NOTICE OF REVISION (NOR)

9. TITLE OF DOCUMENT: HANDLE

12. CONFIGURATION ITEM (OR SYSTEM) TO WHICH ECP APPLIES: MORTAR 81mm M252

9. TITLE OF DOCUMENT: PLATE

CHANGE ZONE D-4

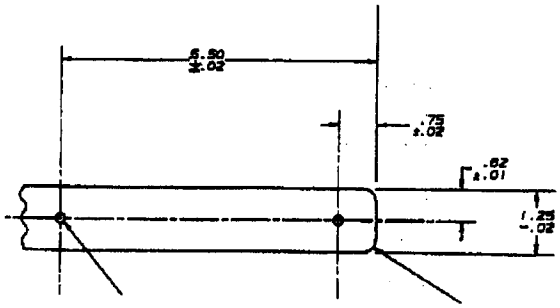
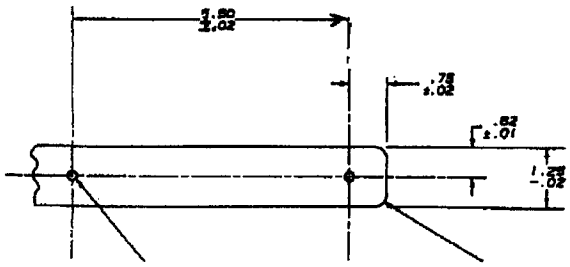
FROM:

TO:

CHANGE ZONE D-4

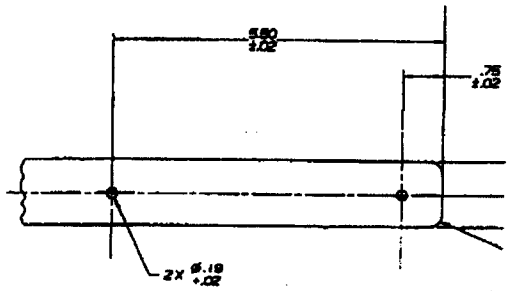
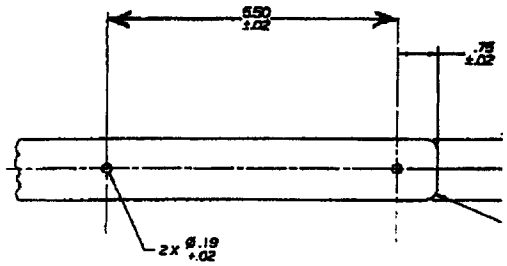
FROM:

TO:
